STAFF REPORT FOR THE HISTORIC REVIEW BOARD

FILE NUMBER: DR-11-05

REQUEST: Accessory Structure

The applicant is proposing an accessory structure in the rear yard of 1883 6th Avenue. The project is subject to the approval criteria in Chapter 25, Historic District.

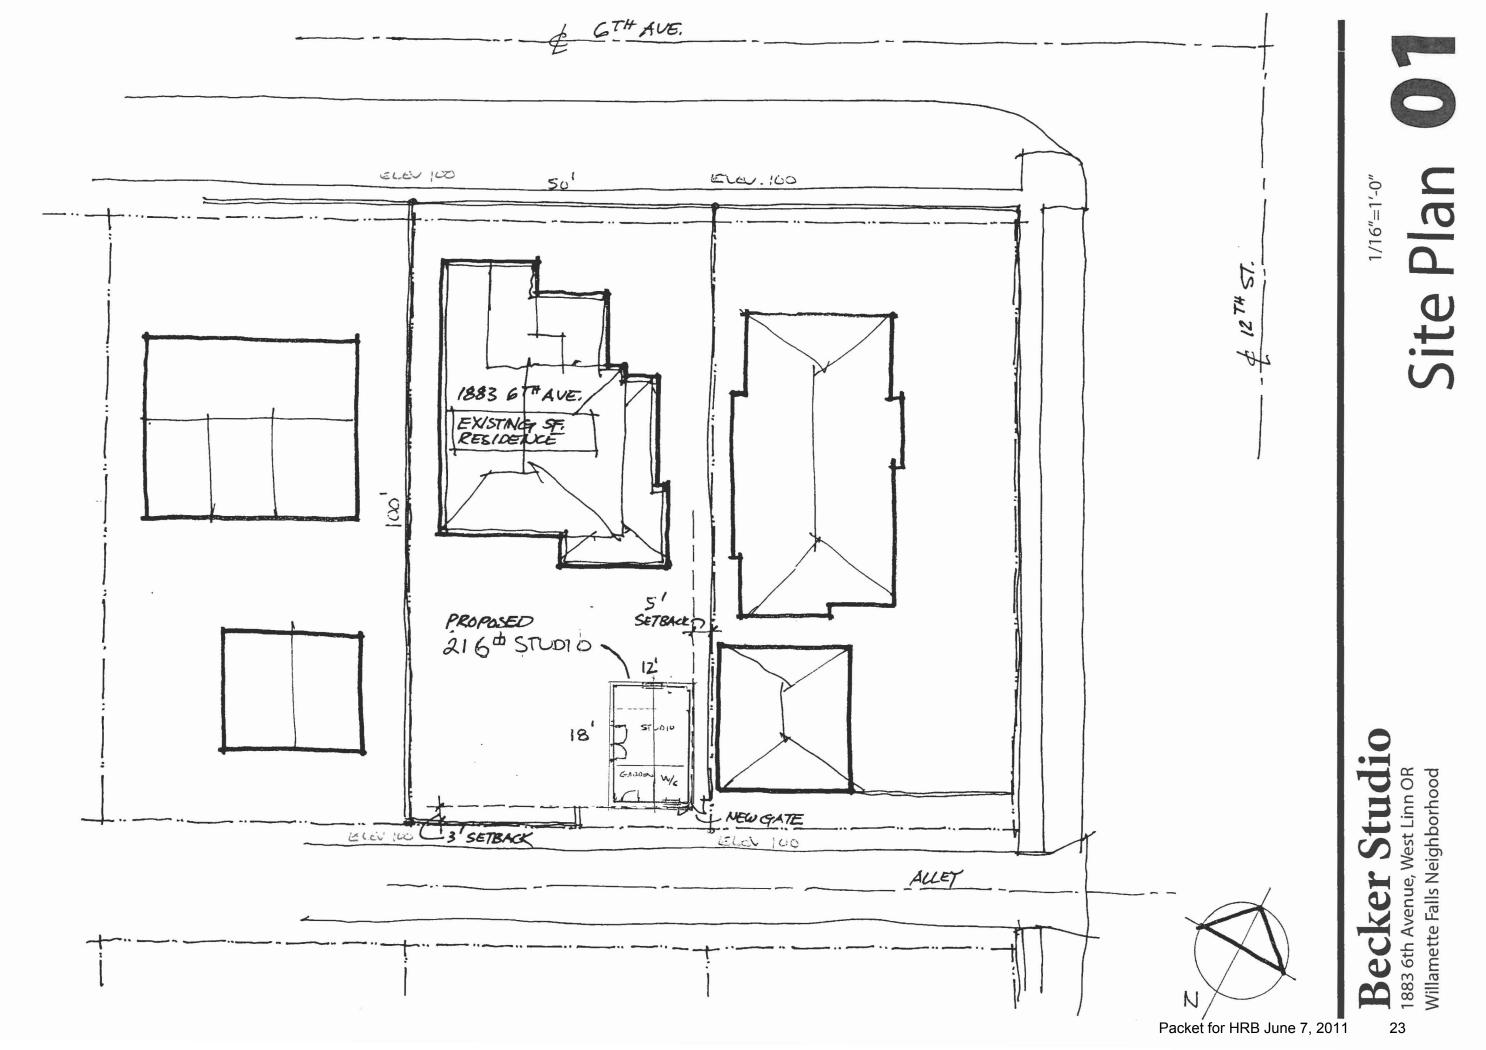
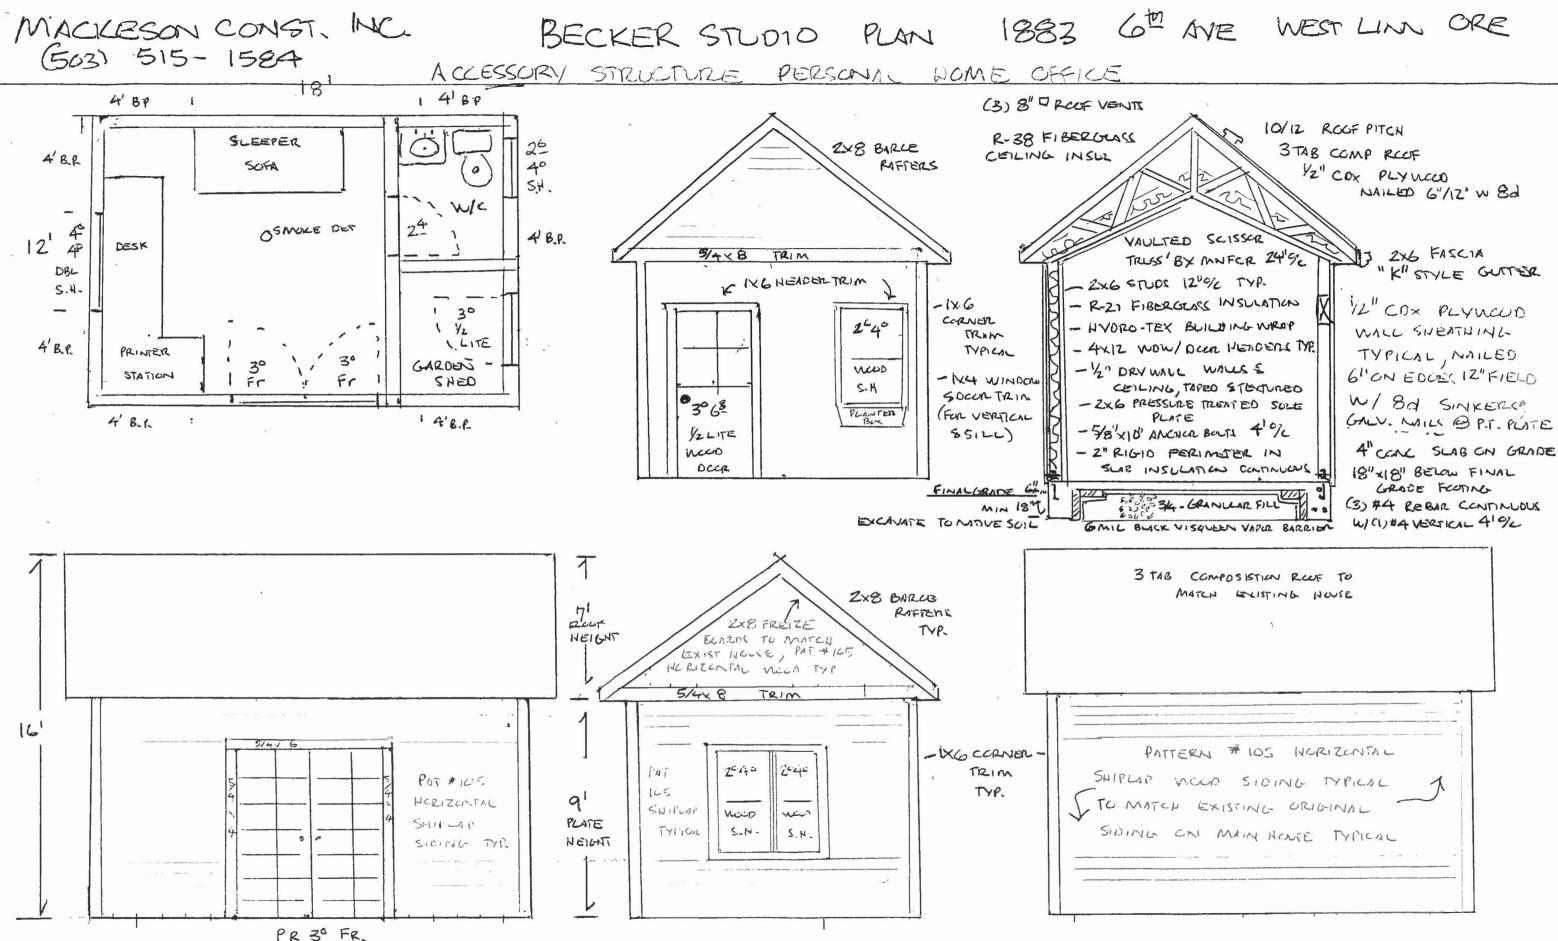
FINDING NO. 2: Criteria 1-3 and 5 do not apply. The proposed accessory structure would be set back 5' from the side property line and 3' from the rear property line (see Exhibit HRB 3, Site Plan). The proposed accessory structure complies with the required lot coverage. The existing structure is 1,132 square feet and the proposed accessory structure is 216 square feet for a total of 1,348 square feet, which is 27 percent and less than the 50 percent maximum that is permitted in the historic district. The criteria are met.

FINDING NO. 3: Criteria 2-4 do not apply. The proposed accessory structure is 16' feet tall. The accessory structure will not compromise character of the front elevation and will not significantly modify the mass of the house as seen from the right-of-way. The applicable criteria are met.

FINDING NO. 4: The proposed accessory structure is 12' in width and 18' in length. The sidewalls are not large enough to require a pop out. The applicable criteria are met.

FINDING NO. 5: The applicant is proposing three recycled/salvaged windows that are 1/1 light. The proportions of the windows would be consistent with the existing windows. The trim will be 4" and will match the existing trim on the rear. One window would be on the elevation facing the rear façade of the house and the other two would be paired and on the rear elevation facing the alley. The criteria are met.

FINDING NO. 6: The applicant is proposing two entries. One is on the elevation that faces the rear of the house and would be a 1 light wood door with true divided and fixed lights. The second entry faces the west and the rear yard. The applicant is proposing French doors with multiple fixed and true divided lights. The trim would be the same width as the window trim. The criteria are met.

FINDING NO. 7: The applicant is proposing 6" horizontal shiplap wood siding for the accessory structure. Shingles are not proposed. The criteria are met.

FINDING NO. 8: The proposed roof is 10:12, which is equal to, but not greater than, the roof pitch of the house. The proposed roof is 3-tab asphalt composition shingle and will match the existing roof. The criteria are met.

- 1. <u>Site plan and elevations</u>. With the exception of modifications required by these conditions, the project shall conform to the plans labeled Site Plan 01 and Becker Studio Plan in Exhibit HRB-3.
- 2. Lighting. Any lighting shall be shielded from the adjacent properties.
